C I T Y O F B O U L D E R
PLANNING BOARD AGENDA ITEM
MEETING DATE: May 26, 2016

AGENDA TITLE:
Public hearing for consideration of a Concept Plan proposal (LUR2016-00028) to redevelop the AirGas site at 3200 Bluff Street, a roughly 1-acre property, with a mixed-use development. The proposal includes two buildings totaling 98,000 square feet in size comprised of 43,000 square feet of residential space with 36 rental units, 55,000 square feet of commercial space, and a 102 space underground parking garage. Preliminary consideration of a rezoning from Industrial Mixed Service (IMS) to Mixed-Use - 4 (MU-4) is also proposed.

DATE OF COMMENTS:	**April 22, 2016**
CASE MANAGER:	**Karl Guiler**
PROJECT NAME:	**3200 Bluff Street Mixed Use**
LOCATION:	**3200 BLUFF STREET**
COORDINATES:	**N04W03**
REVIEW TYPE:	**Concept Plan Review & Comment**
REVIEW NUMBER:	**LUR2016-00028**
APPLICANT:	**KIRSTEN EHRHARDT**
DESCRIPTION:	**CONCEPT PLAN REVIEW AND COMMENT: Request for citizen, Planning Board, and city comment on a proposal to develop an existing roughly one acre property (the AirGas site) with a mixed-use development in two buildings totaling 98,000 square feet in size comprised of 43,000 squar

Figure 5- Conceptual Site Plan

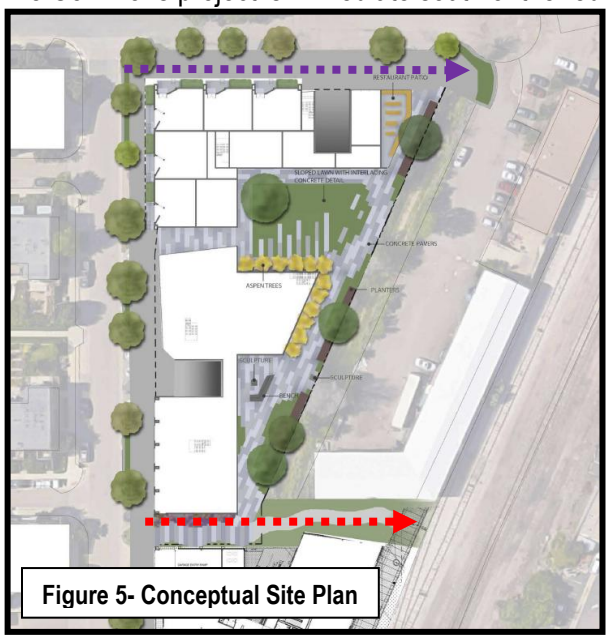
At the point where the pedestrian passage enters the site midway along the Junction Place frontage, staff suggests a small gathering space with seating, planters etc. consistent with the goal above. Staff also suggests that this penetration be located as to align with the east-west pedestrian pathway in the Steel Yards development across the street.

The proposed plan includes retail and commercial uses along the ground floor along Junction Place. As stated below relative to the rail plaza, it would also be important to have more robust commercial uses location along Bluff Street nearest to the future rail plaza area.

Figure 9- Pedestrian circulation suggestions

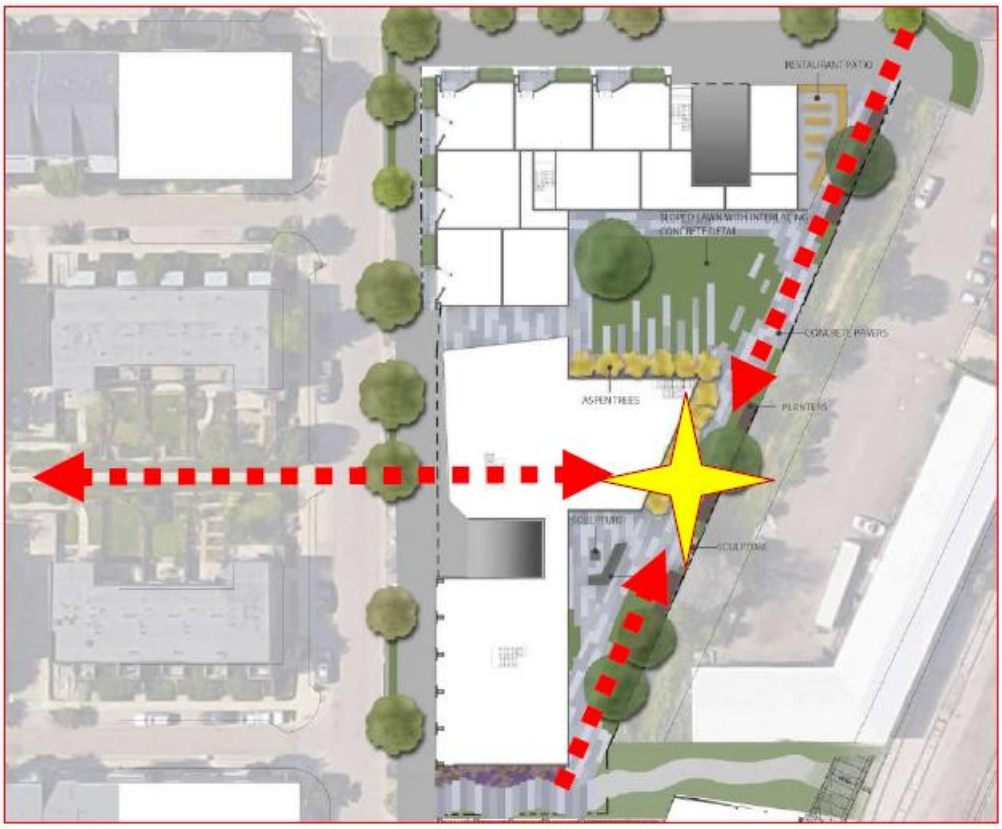
As stated above, staff supports the land use mix on the site and finds it generally consistent with TVAP. However, based on the guidelines and considering the context around the site, staff has created the following specific list of suggested modifications to create a greater level of consistency with TVAP, a more improved site layout, and enhanced connection to its surroundings (see **Attachment C** for Development Committee Review comments):

- Any residential along Junction Place or Bluff Street should have stoop entries to provide good separation from the street, but have inviting entries to building;

- Consider more functional balcony spaces for the residential uses;
- Create or allow for a pedestrian connection between the pedestrian connection the south side of the site with the Commons project, and

- Align the mid-block pedestrian penetration into the site with the existing east-west pedestrian walkway in Steel Yards and use the opportunity to create an attractive landscape/open space node on the interior of the site that would terminate the vistas from the west pedestrian walkways as well as from the pedestrian walkways on the north and southeast portions of the subject site. This may require reconfiguration of the interior courtyard (see Figure 9 as follows). Staff encourages design on the elevated glass/wood second floor connection (consider a greater level of transparency as well) as an additional focal point when viewed from Steel Yards;

PRECEDENTS - LANDSCAPE

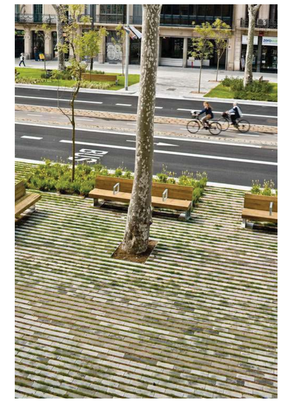
2. The precedent images on sheet CP-9 present interesting options, but they must be carefully customized to succeed in the specific local conditions. The image of the un-mown native grass is particularly applicable. Pavers with strips of turf may prove extremely difficult to maintain.

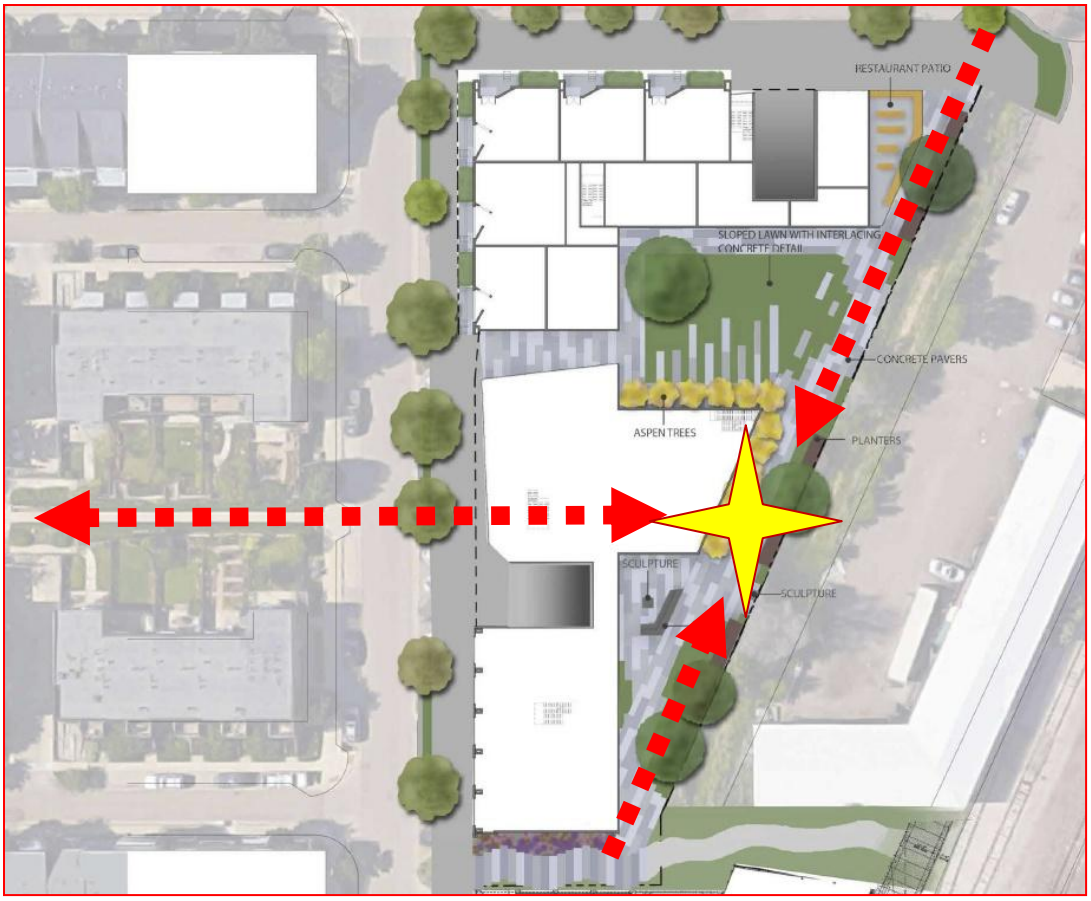
- Staff supports the roof deck, as proposed, but needs to know more about whether it would be open to both the residential and commercial components;
- Consider more functional balcony spaces for the residential uses;

- Create or allow for a pedestrian connection between the pedestrian connection the south side of the site with the Commons project, and
- Align the mid-block pedestrian penetration into the site with the existing east-west pedestrian walkway in Steel Yards and use the opportunity to create an attractive landscape/open space node on the interior of the site that would terminate the vistas from the west pedestrian walkways as well as from the pedestrian walkways on the north and southeast portions of the subject site. This may require reconfiguration of the interior courtyard. Staff encourages design on the elevated glass/wood second floor connection (consider a greater level of transparency as well) as an additional focal point when viewed from Steel Yards;
